Metro Inner-South Joint Development Assessment Panel Agenda

Meeting Date and Time: Wednesday, 14 June 2023; 9:30am
Meeting Number: MISJDAP/145
Meeting Venue: City of Fremantle
151 High Street, Fremantle

8.1 No.87 -93 (Lot 363 & 364) Queen Victoria Street, Fremantle

Development Description:	Service Station Redevelopment
Applicant:	Planning Solutions
Owner:	Bass Management Pty Ltd
Responsible Authority:	City of Fremantle
DAP File No:	DAP/23/02455

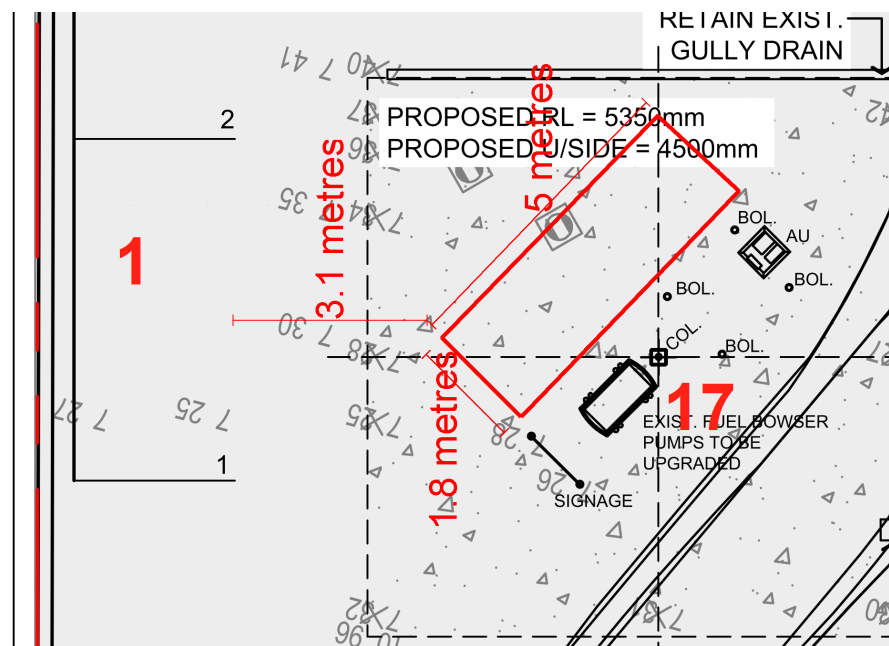
Regarding access to the parking bays to the northeast of the lot. Proposed car bays 1 and 2 were previously occupied by an LPG tank which, if the adjacent fuel bowser bay was in use, would have prevented access to the rear parking bays between the fuel bowser and LPG tank entirely. It is considered that the removal of the LPG tank and the installation of parking bays in its place is an improved outcome. If the bowser on the northernmost end is in use, given the average width and length of a car, 1.8m and 5m respectively, there should remain sufficient space for a car to navigate between car bay 1 and a car parked at the adjacent fuel bowser (refer image below).

Car bay 2 will be accessed via driving through car bay 1 or, if this car bay is occupied, potentially driving in forward gear or reverse parking into this bay.

Prior to the lodgement of a Building Permit application for the development hereby approved, the applicant is to submit, and have approved to the satisfaction of the City of Fremantle, a detailed parking plan design which complies with the Australian Standard AS/NZS 2890 and AS/NZS 1428.
